APPENDIX G

COMMENTS OF TALEN MONTANA, LLC ON THE PROPOSAL ON NATIONAL EMISSION STANDARDS FOR HAZARDOUS AIR POLLUTANTS: COAL- AND OIL-FIRED ELECTRIC UTILITY STEAM GENERATING UNITS REVIEW OF THE RESIDUAL RISK AND TECHNOLOGY REVIEW

Docket ID: EPA-HQ-OAR-2018-0794

Figure 1 - Diagram of Colstrip Scrubber

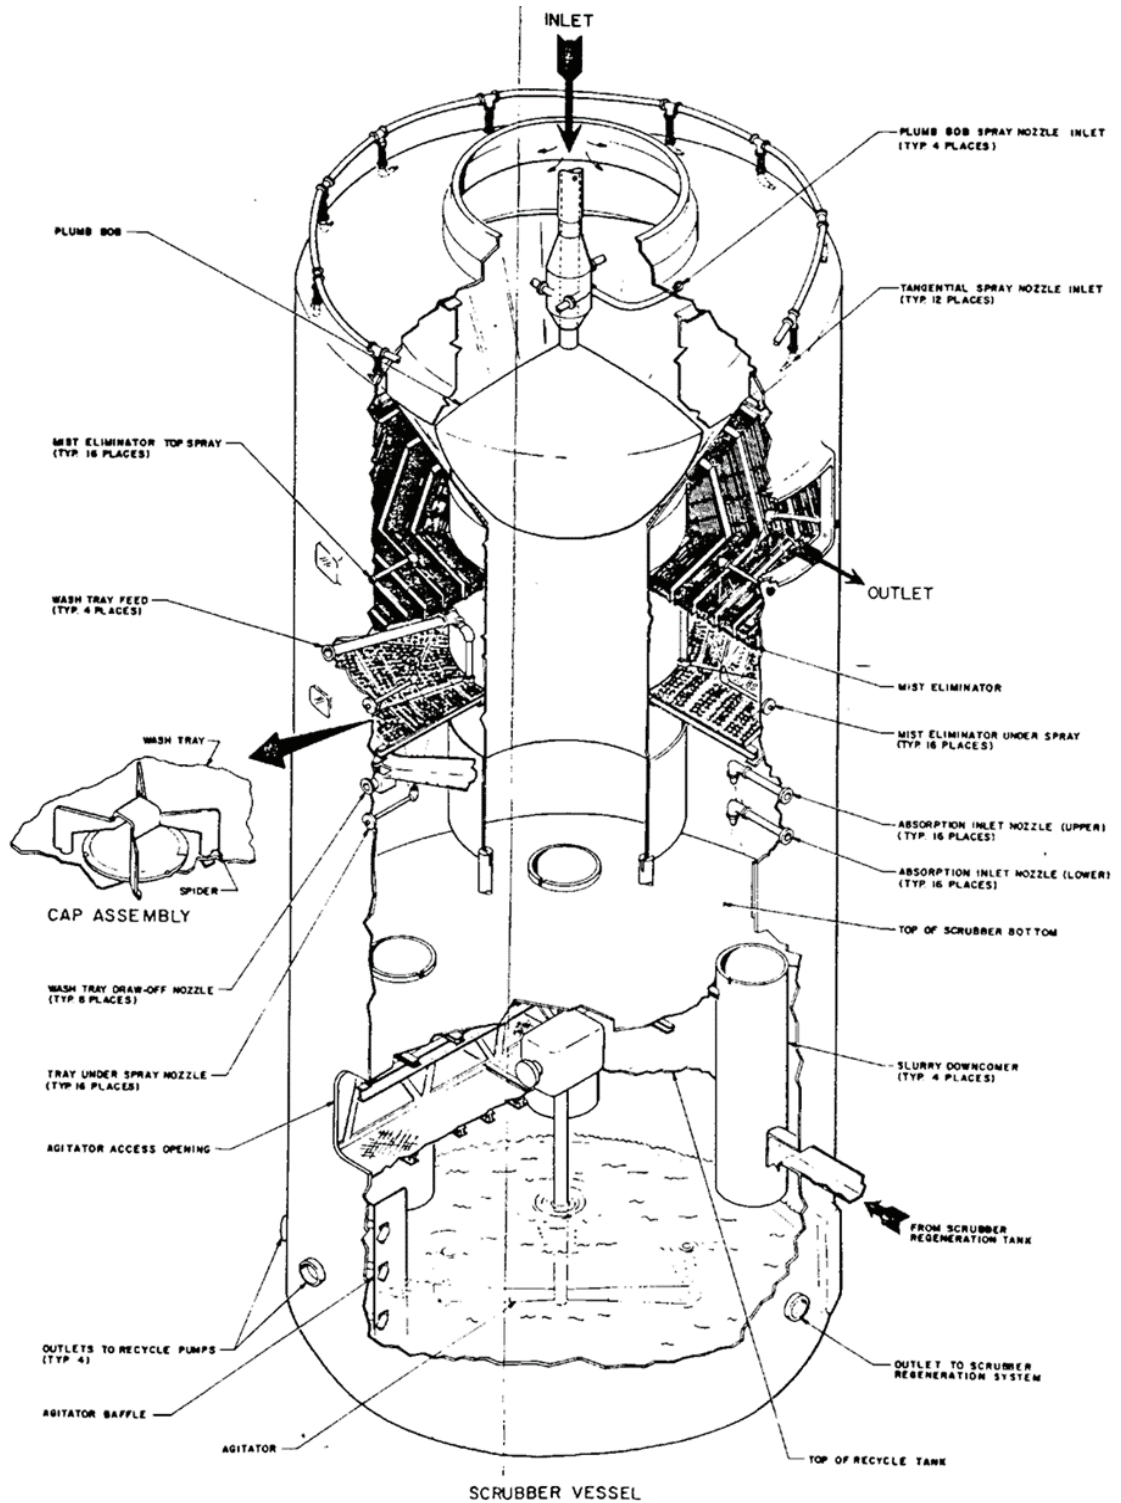
The venturi wet scrubbers at Colstrip Units 3 and 4 remove approximately 99.7% of fly ash particulate from the flue gas and 95% of the SO₂ via a sequence of removal processes. The flue gas enters the scrubber vessel and is accelerated by the converging surfaces of the plumb bob and venturi bowl. The flue gas and slurry meet in the venturi throat where turbulence atomizes the slurry. Acceleration of the flue gas causes the particulate to collide with and be absorbed by slurry droplets. The majority of the fly ash particulate and most of the SO₂ are removed in the venturi section. The wet venturi scrubbers utilize the alkalinity of the fly ash particle removed to help meet the high level of SO₂ removal. The throat area of the venturi is adjusted by moving the plumb bob up or down to obtain the desired pressure drop across the plumb bob of each scrubber. The flue gas velocity caused by this pressure drop ensures optimum fly ash removal. The slurry and collected fly ash are separated from the flue gas as it turns up to enter the absorption area. The flue gas then enters the absorption spray area in the annular space between the downcomer and shell of the scrubber vessel. The flue gas is contacted with recycle slurry for additional removal of SO₂. Above the absorption section is the wash tray which uses recirculation water to contact the flue gas and remove entrained recycle slurry from the flue gas. The flue gas then flows through the mist eliminator where entrained droplets are removed.

As EPA recognized, Colstrip does not have a FF or an ESP and would need to install one to comply with the proposed 0.010 lb/MMBtu fPM limit, as the current venturi wet scrubbers will not be able to meet the proposed limit.² While EPA recognizes that Colstrip’s venturi wet scrubbers would not be able to comply with the proposed limit, EPA assumes Colstrip could make a “minimal cost (\$10/kW) for [wet scrubber] maintenance or minor upgrades . . . to meet a potential 0.015 lb/MMBtu standard.”³ This assumption, however, is inaccurate. Colstrip has typically been able to remain just below the current limit of 0.030 lb/MMBtu. However, due to occasional variability in fuel and operating condition, Colstrip has, since 2018, hired consultants and engineers to explore ways to further enhance the efficiencies of the venturi wet scrubbers. This work, as described below, has made the venturi wet scrubber emissions more stable. But, as reflected in Attachment A (Colstrip’s MATS PM CEMS compliance data from September 2018 to April 2023), the work demonstrated that 0.015 lb/MMBtu fPM is not achievable with upgrades to the existing wet scrubbers and further that the efforts to reduce fPM emissions with the existing control technology has reached its limits:

- The original operating condition for the plumb bob delta P (pressure drop) was 17” to meet particulate and SO₂ removal requirements. In an effort to optimize the performance of the scrubbers, the plumb bob delta P is currently operated at 27-28”, the maximum delta P achievable which is limited by the capability of the induced draft (“ID”) Fans.
- The original mist eliminators have been upgraded with improved performance to better control entrained droplets in the flue gas. In 2018, the mist eliminator supplier (Munters)
